<b>Office Action Summary</b>	<b>Application No.</b> 10/801,842	<b>Applicant(s)</b> PHELPS ET AL.	
	<b>Examiner</b> Amy J. Sterling	<b>Art Unit</b> 3632

This is the first Office Action for application number 10/801,842, Electronic Device Cradle Having Replaceable Latches, filed on 3/16/04. Claims 1-19 are pending.

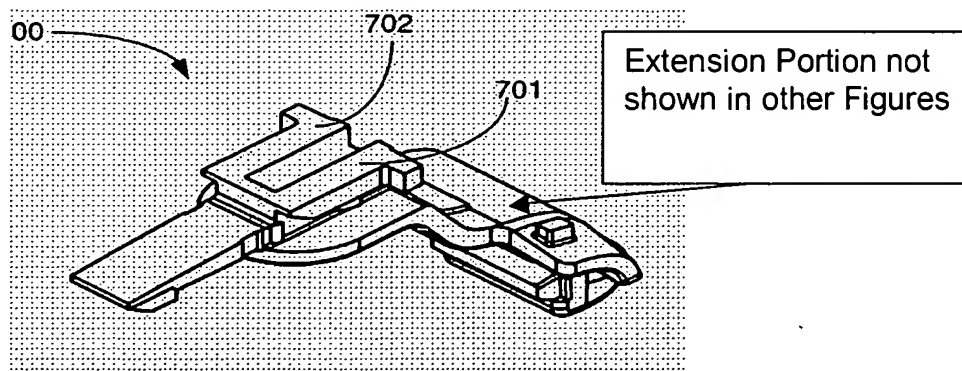
The applicant has argued that there are only two latches embodiments. This is unpersuasive in that Figure 7 does not appear to be the stabilizer of either of the recited first or second latch in that it has an extension portion (See Below) which is not shown elsewhere in the figures. Figure 7 is still considered a patentably distinct species.

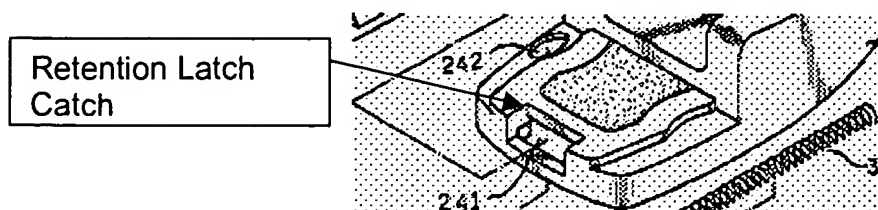
The patent to Chen discloses a cradle (10, 20) and latch assembly having a body (10, 20), the body having at least one pocket (21), at least one latch aperture (241) and a latch (35) having a clasp (end of 351) and a means for coupling (353, 354, 356) to the body and a clasp arm (middle of 351) having a clasp arm length wherein the latch is detachable from the body (10, 20). Chen discloses wherein the means for coupling includes a retention latch arm (354) and a retention latch (356), wherein the retention latch arm (354) acts as a cantilever beam and wherein the latch has a thumb release (31), a stabilizing support (33) and a rear support (36) and wherein the body has a retention latch catch (the upper lip of the area surrounding the latch aperture, which catches the retention latch 356, See Drawing Below), a rear support recess (11), a latch guide (246) and a rotation support (22, 23).
